# Environmental Impact Statement

Harquahala Valley Watershed

Maricopa and Yuma Counties, Arizona

March, 1977

<p>PLATE 4 SADDLEBACK DIVERSION MARICOPA &amp; YUMA COUNTIES, ARIZONA PRELIMINARY PLANS MARCH, 1976</p>			
ARIZONA WATER COMMISSION		STATE OF ARIZONA	
Drawn by BJE	Date 2/8/76	Approved by	
Checked by LAM	Date 4/1/76	Reviewed by	
Designed by		Checked by	
Drawn by		Reviewed by	
Checked by		Approved by

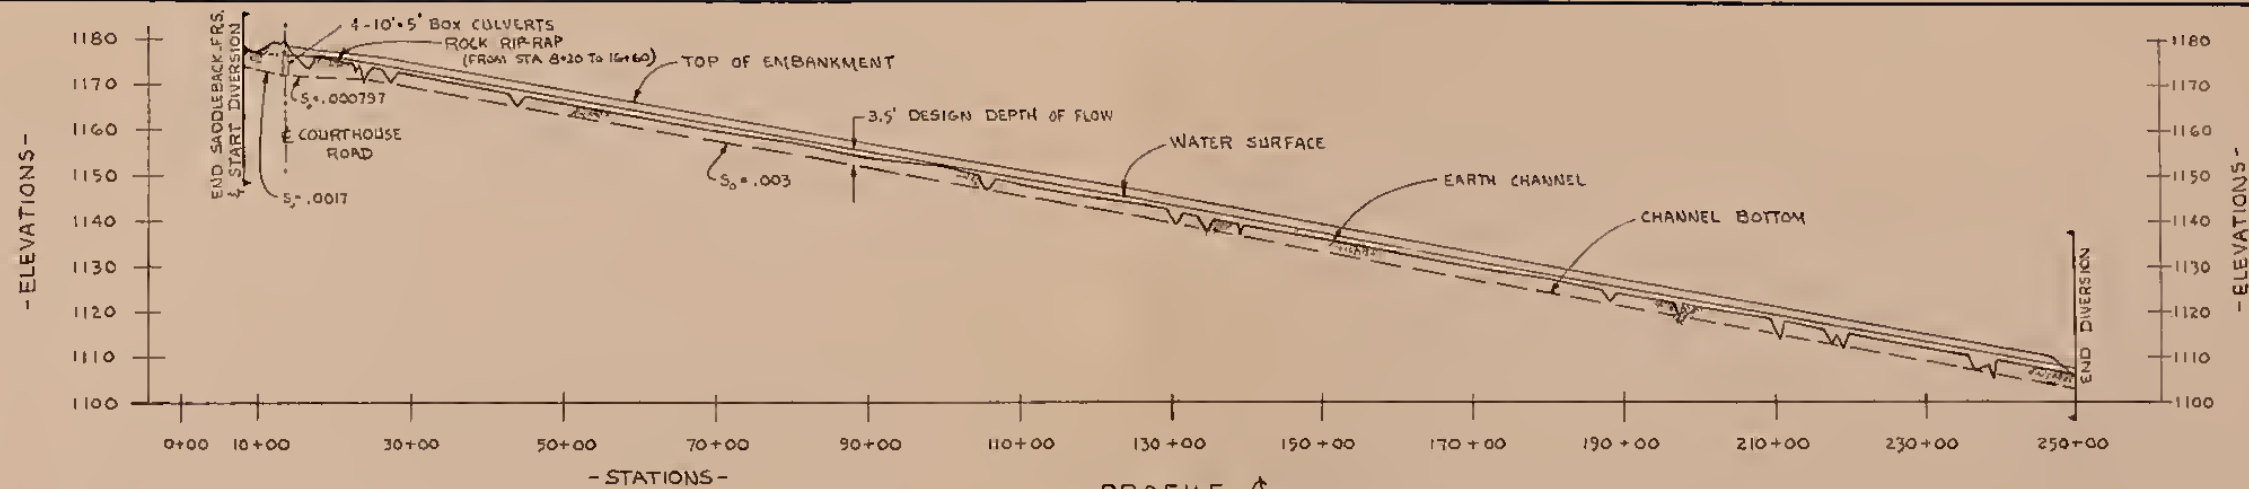
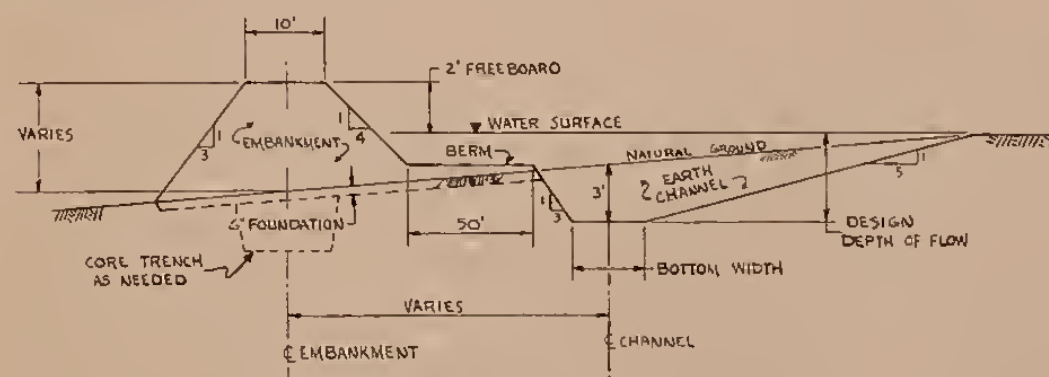
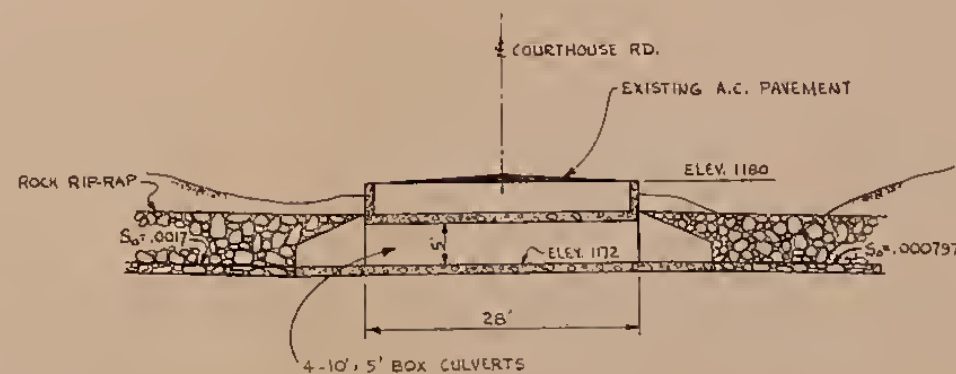
Comment: From pages III-17, III-18 and Plate 4 of the study we note that floodwater will be released from the Saddleback Diversion into a drainage way leading to Centennial Wash. Four El Paso Natural Gas Company pipelines cross the drainage-way between the diversion outlet and Centennial Wash and will be subject to the concentrated water flow.

Response: (Comment refers to the road crossing over Saddleback Diversion. See Plate 4) The width of the box will be decided by negotiation between the Flood Control District and Maricopa County Highway Department. The plans (see Plate 4) still show a width of 28 feet. This may be increased to 50 feet in final design. In any event, a change from 28 feet to 50 feet is not viewed as a significant action requiring that the issue be resolved for the purpose of the final environmental statement.

Figure 2

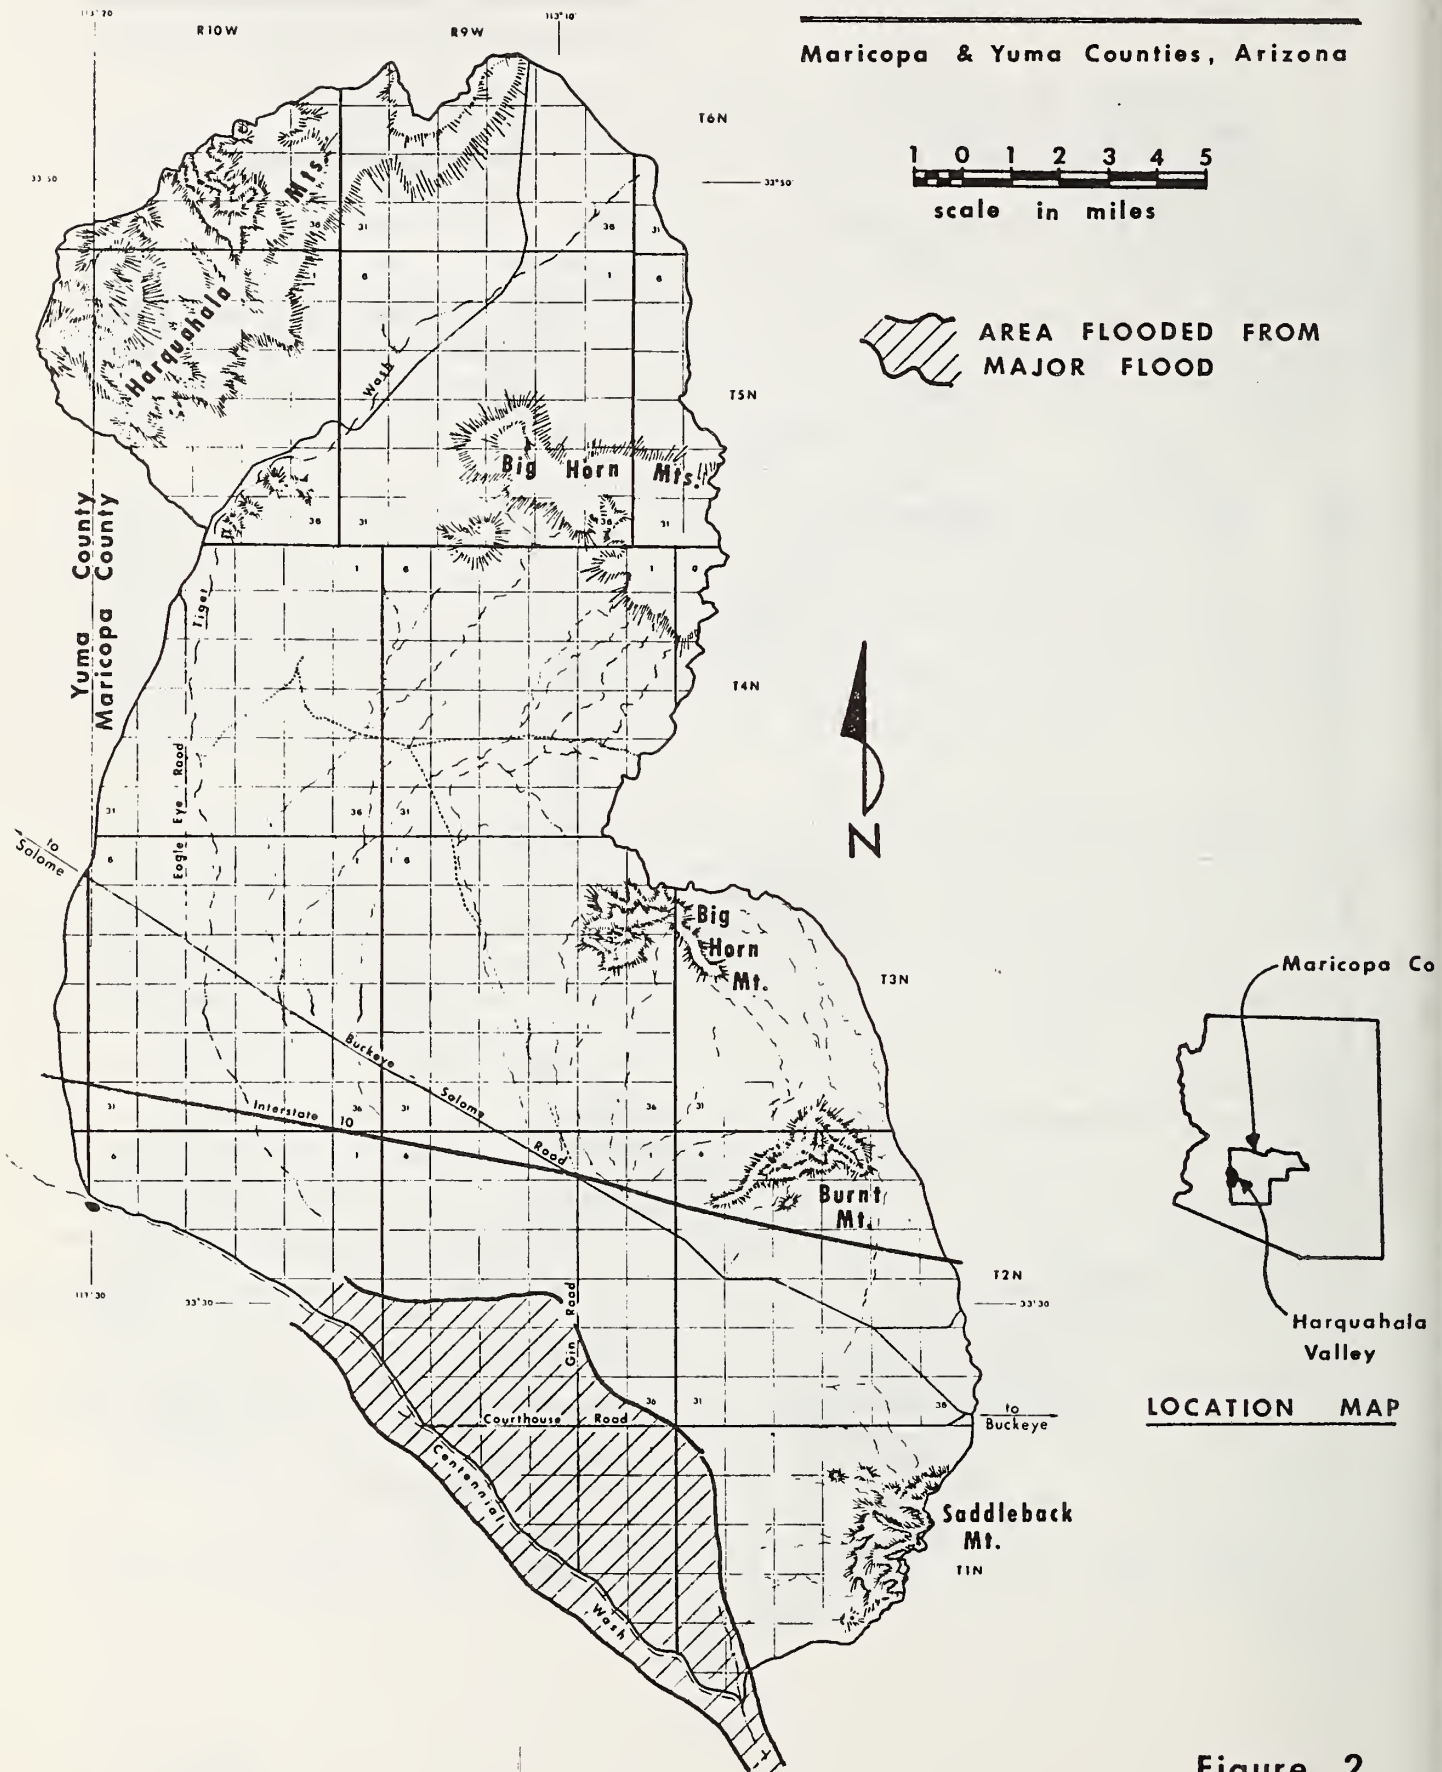
Page III-72, Figure 2 - From the local contour, it appears that flooding could extend to the south side of Centennial Wash to a greater degree than depicted.

Response: (Reference is to Figure 2, Centennial Wash Flood Plain Map.) Some degree of detail has been lost because of the small map size. The southern boundary of the floodline on Centennial Wash is shown in greater detail on Plate 5, Centennial Levee.
